ATTACHMENT B

RETYPE TECHNICAL SPECIFICATION PAGES

DPR-29

QUAD CITIES  
DPR-29

Figure 4.6-2

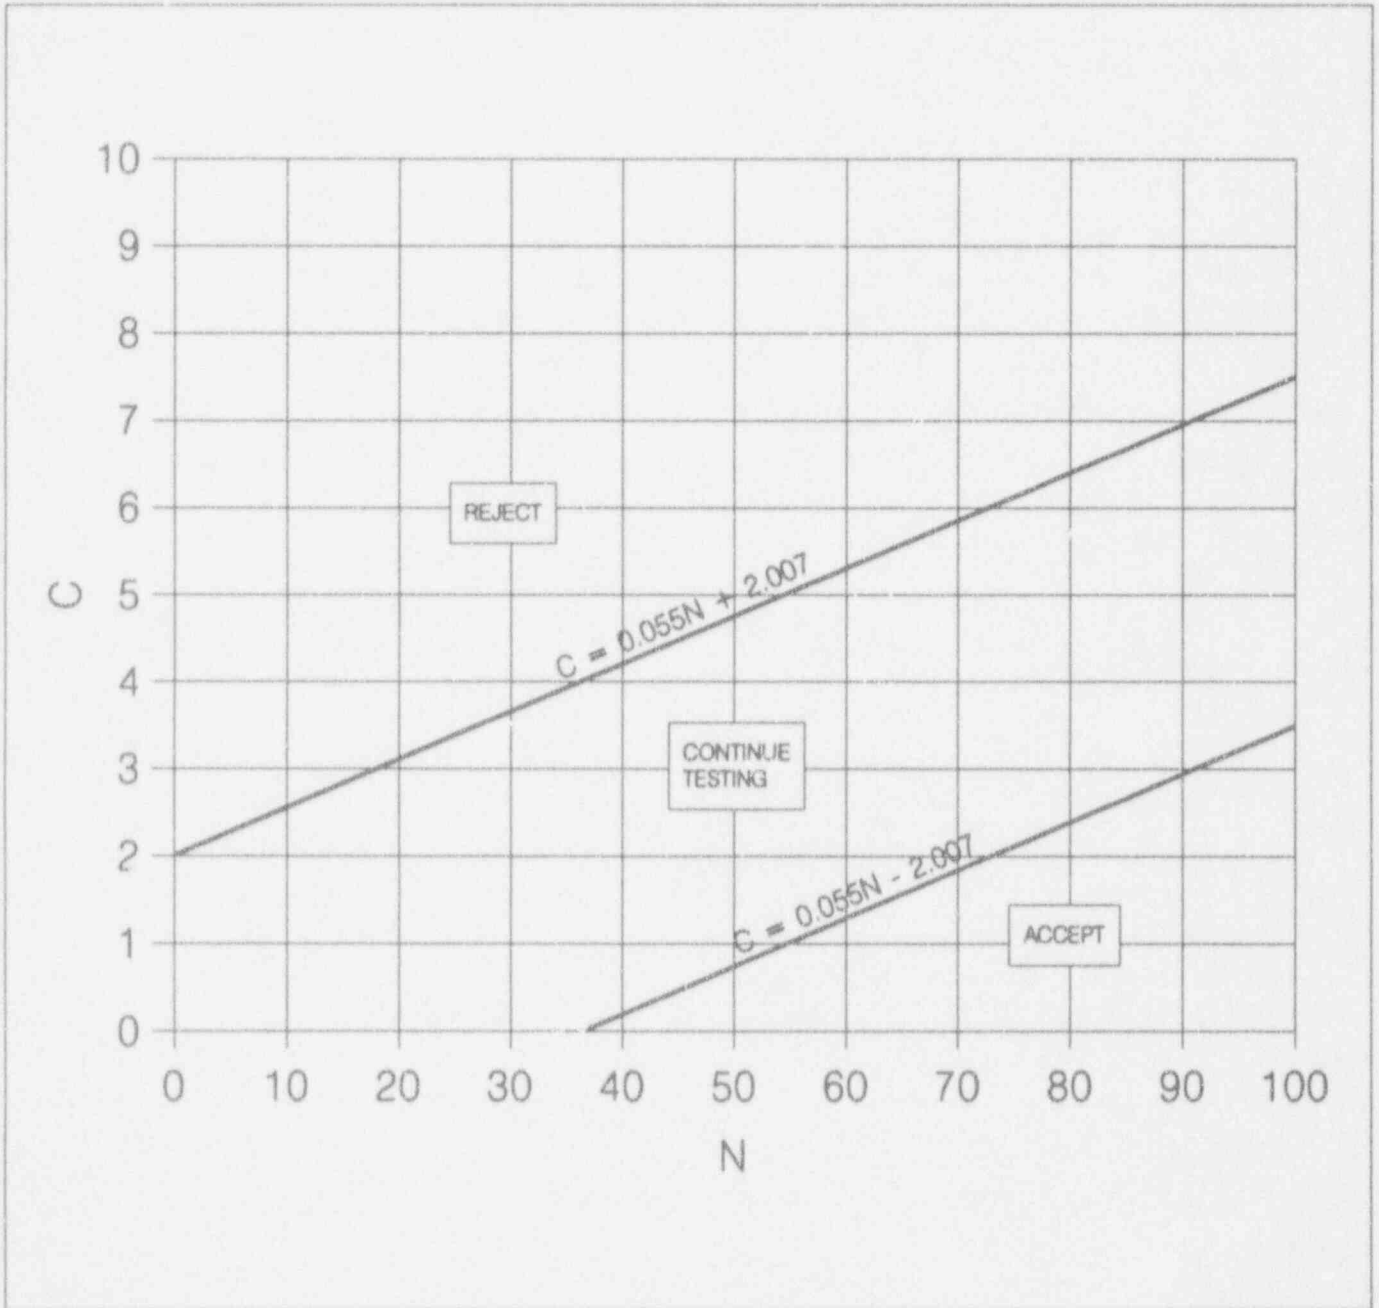
- a. At least 10% of the total of each type of snubber shall be functionally tested either in-place or in a bench test. For each snubber of a type that does not meet the functional test acceptance criteria of Specification 4.6.1.6, an additional 10% of that type of snubber shall be functionally tested until no more failures are found or until all snubbers of that type have been functionally tested; or
- b. A representative sample of each type of snubber shall be functionally tested, in accordance with Figure 4.6-2. "C" is the total number of snubbers of a type found not meeting the acceptance requirements of Specification 4.6.1.6. The cumulative number of snubbers of a type tested is denoted by "N". At the end of each day's testing, the new values of "N" and "C" (previous day's total plus current day's increments) shall be plotted on Figure 4.6-2.

1. Functionally test 10% of a type of snubber with an additional 10% tested for each functional testing failure, or
2. Functionally test a sample size and determine sample acceptance or rejection using Figure 4.6-2, or

Figure 4.6-2 was developed using "Wald's Sequential Probability Ratio Plan" as described in "Quality Control and Industrial Statistics" by Acheson J. Duncan.

Figure 4.6-2

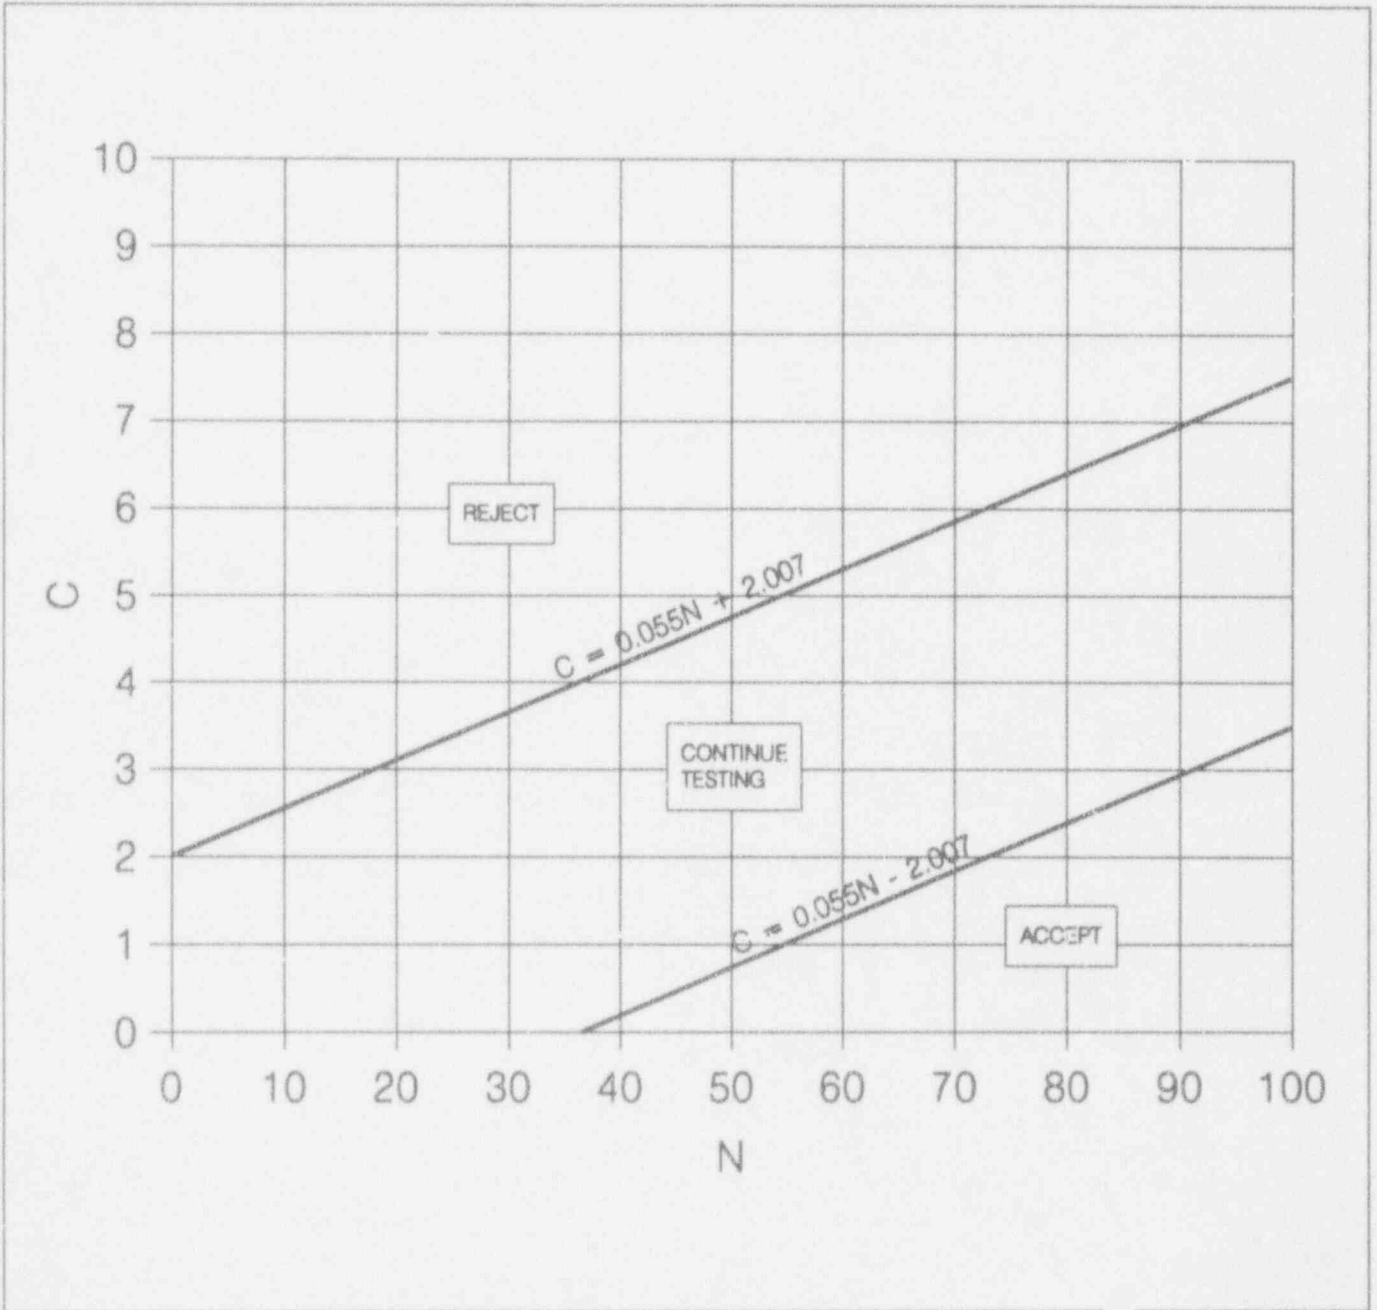
- a. At least 10% of the total of each type of snubber shall be functionally tested either in-place or in a bench test. For each snubber of a type that does not meet the functional test acceptance criteria of Specification 4.6.1.6, an additional 10% of that type of snubber shall be functionally tested until no more failures are found or until all snubbers of that type have been functionally tested; or
- b. A representative sample of each type of snubber shall be functionally tested, in accordance with Figure 4.6-2. "C" is the total number of snubbers of a type found not meeting the acceptance requirements of Specification 4.6.1.6. The cumulative number of snubbers of a type tested is denoted by "N". At the end of each day's testing, the new values of "N" and "C" (previous day's total plus current day's increments) shall be plotted on Figure 4.6-2.

1. Functionally test 10% of a type of snubber with an additional 10% tested for each functional testing failure, or
2. Functionally test a sample size and determine sample acceptance or rejection using Figure 4.6-2, or

Figure 4.6-2 was developed using "Wald's Sequential Probability Ratio Plan" as described in "Quality Control and Industrial Statistics" by Acheson J. Duncan.
